MEETING NOTES – Mitchell Freeway Southbound Widening Project

Date:	1 November 2018	Time:	6.00PM	Location:	Mt Hawthorn Lesser Hall
Distribution:	Members of the CRG and MRWA project webpage				
Attendees:	Andrew Graham	BMD	Tom Barratt	Resident	
	Anna Massey	Resident	Vivian Warren	BMD	
	Brian Carty	Resident	Reena Roy	Resident	
	Cyril Eliopulos	Resident	Warren Apter	Department of Transport	
	Jamie Robertson	BMD	Eric Jensen	Resident	
	Jeff Williams	Resident	Feargal O'Hara	Main Roads	
	Kathryn Paddick	Main Roads			
	Peter Bull	Resident			
	Philip Taylor	Resident			
	Pina Christie	Resident

PRINCIPAL SEPARATED PATH - SPLIT
N.T.S.

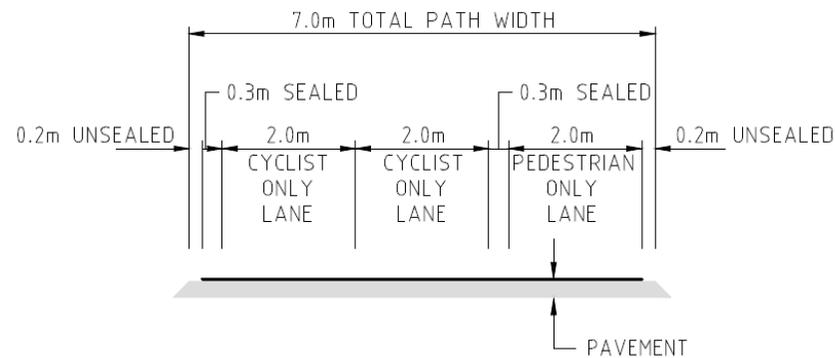
- Separated from traffic by concrete barrier approximately 1m high.
- Includes two underpasses at Hutton Street ramps and one bridge over Scarborough Beach Road.
- Cyclists and pedestrians are separate by red asphalt (cyclists) and black asphalt (pedestrians) from Goody Close to McDonald Street.
- There are two designs – separated and split. The split starts at McDonald Street to Hutton Street.
